**CITY OF KELOWNA
MEMORANDUM**

APPLICATION NO. DP06-0141

AT: 4760 Lakeshore Rd.

PURPOSE: TO MAKE VARIOUS AMENDMENTS TO THE PREVIOUSLY APPROVED DEVELOPMENT PERMIT ALLOWING A 2 ½ -STOREY, 25-UNIT APARTMENT BUILDING

BOAT STORAGE SCREENING

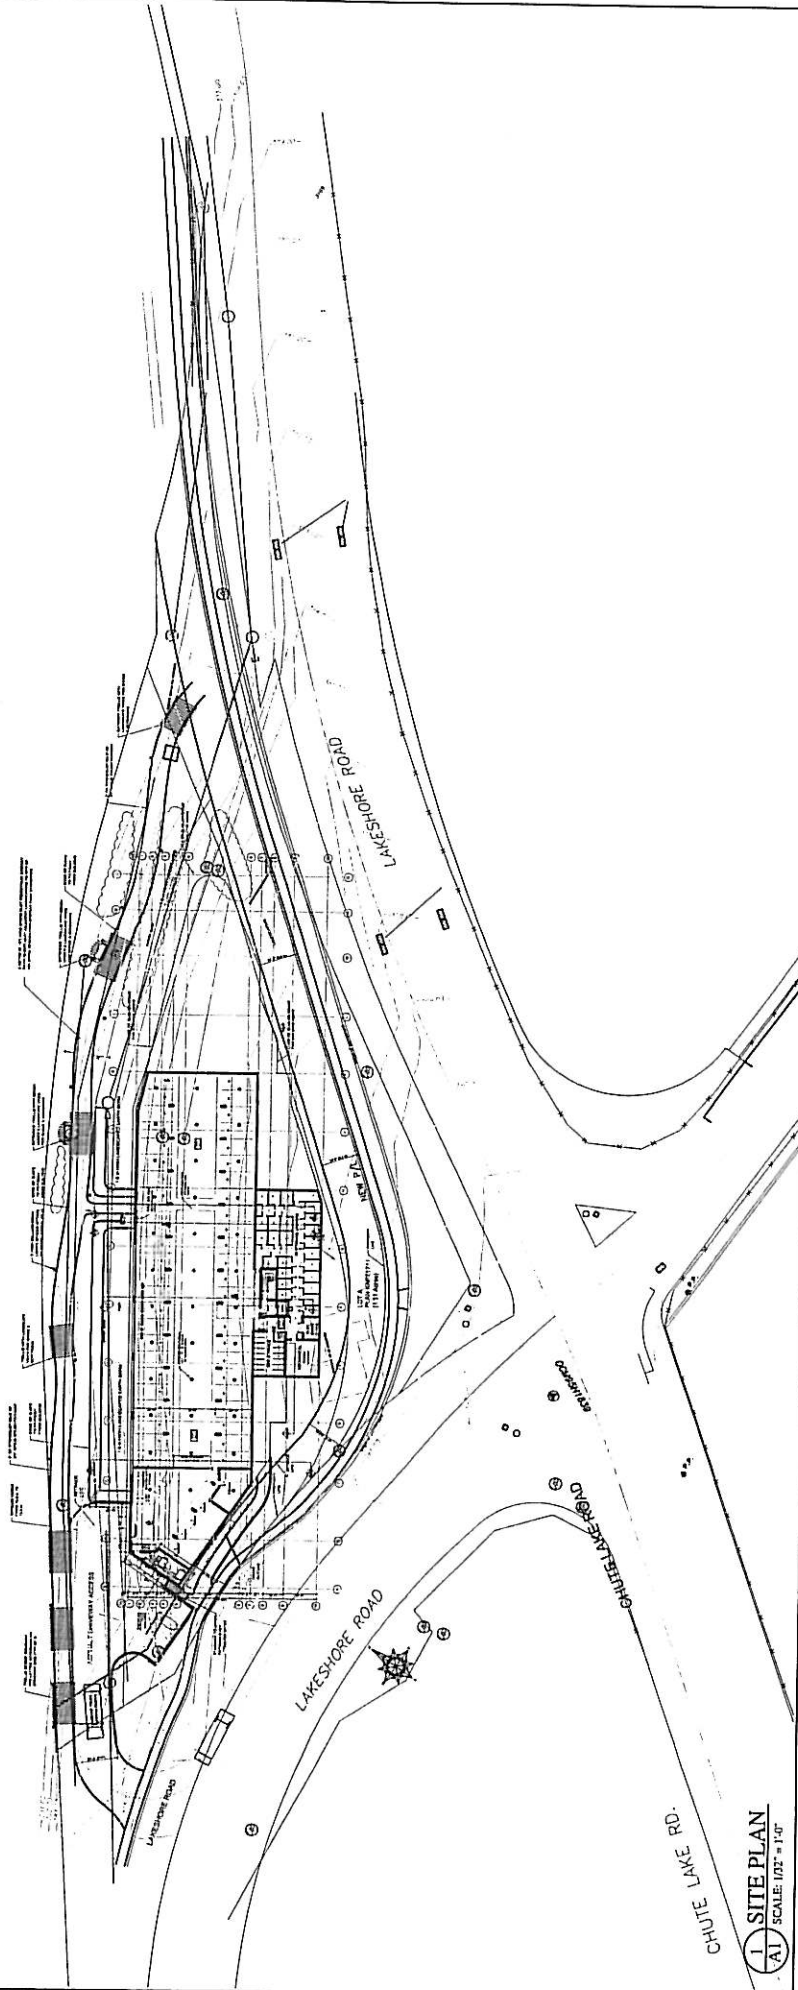
Changes to parking are also proposed. Parking allocated to units is proposed at 52 stalls, an increase from 46 stalls previously proposed. Visitor parking is proposed at 6 stalls, a decrease from 8 stalls previously proposed, although the parking proposed exceeds the minimum standards and is at the maximum allowable. An area now proposed as boat parking will be buffered from Lakeshore Road with landscaping.

The project has also provided a proposed revised landscape plan, with additional provisions for landscaping treatment for a new proposed boat storage area along the Lakeshore Road property boundary.

3 LEVEL 3 - SWIMMING POOL AREA
A5 SCALE: 1/4" = 1'-0"

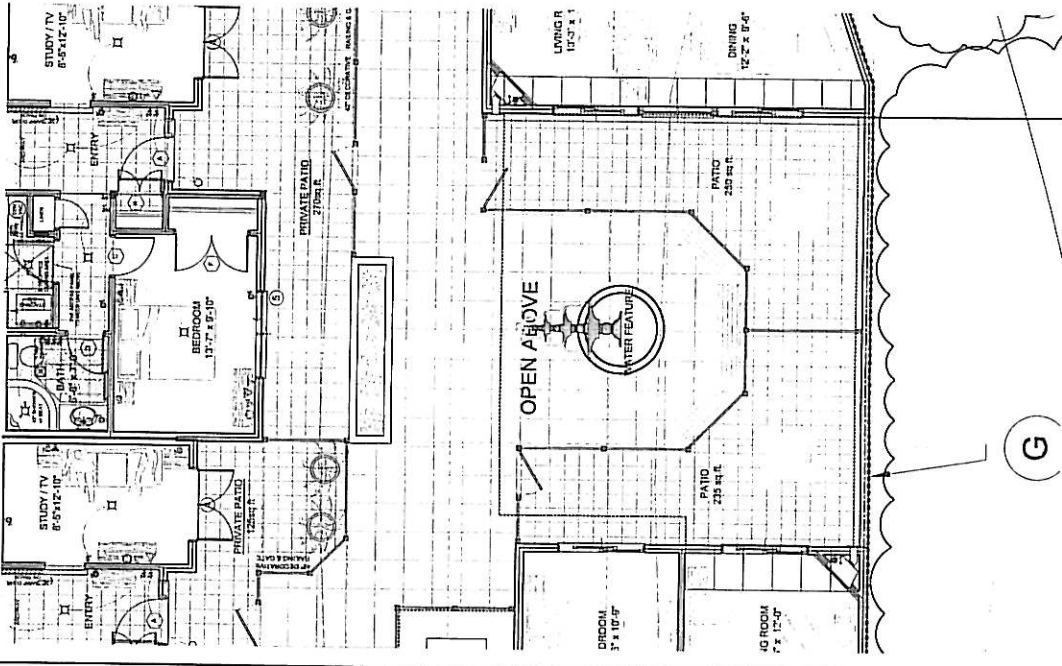
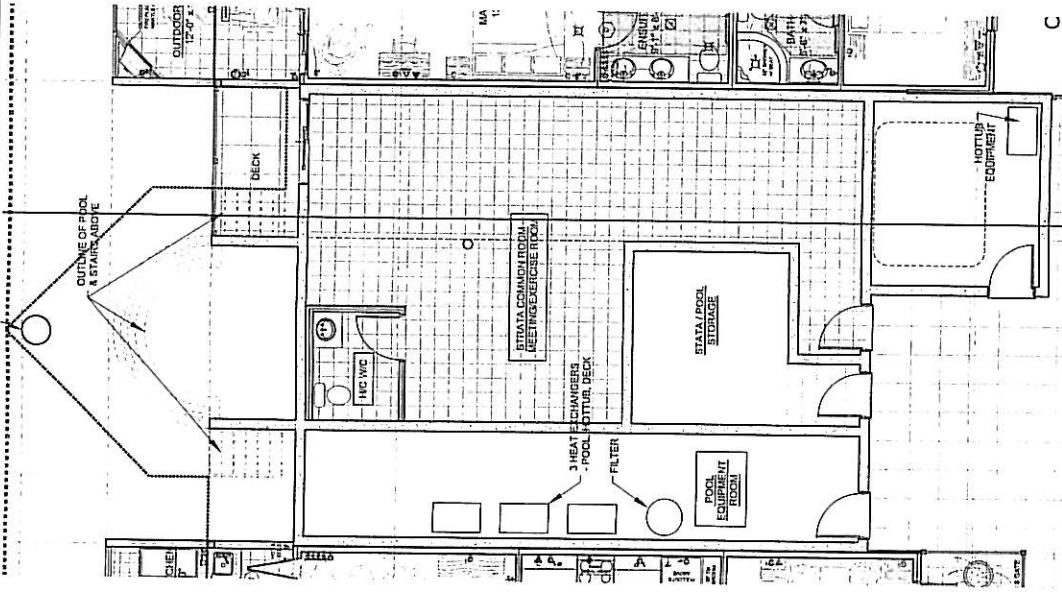
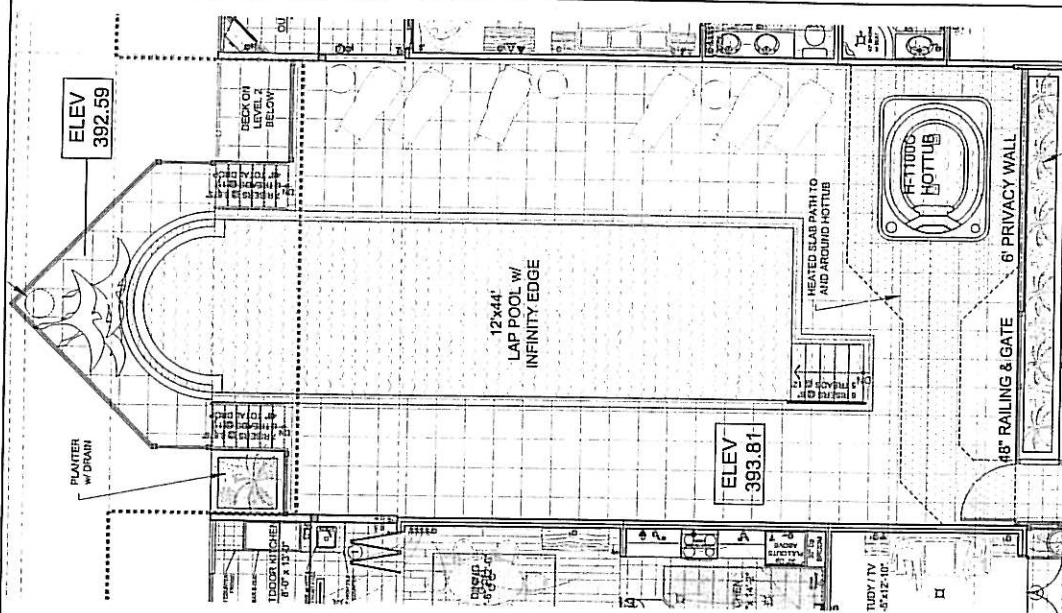
In order to facilitate the required structural changes in the location of the common pool from the middle of the building on level 3 to west side of the building on level 1, various other amendments have resulted, specifically to the allocation of the units:

The project as originally proposed cannot be built with the original location of the pool, creating considerable structural difficulties. Therefore, the proposed change in location of the common pool resulted in changes to the façade and elevations that are not minor and require re-consideration by Council. The form and character of the building overall, remains essentially unchanged in terms of the exterior finishing and proposed building materials. However, the relocation of the pool structure has modified the massing of the building to create a continuous roofline, whereas previously the roofline was broken to accommodate the pool within the centre of the top floor. This primarily influences the west and east elevations, viewed from both the lakefront and Lakeshore Road exposures. Additionally, the originally proposed public art birds sculpture for the third floor that was part of the original submission is no longer included in the finished building.
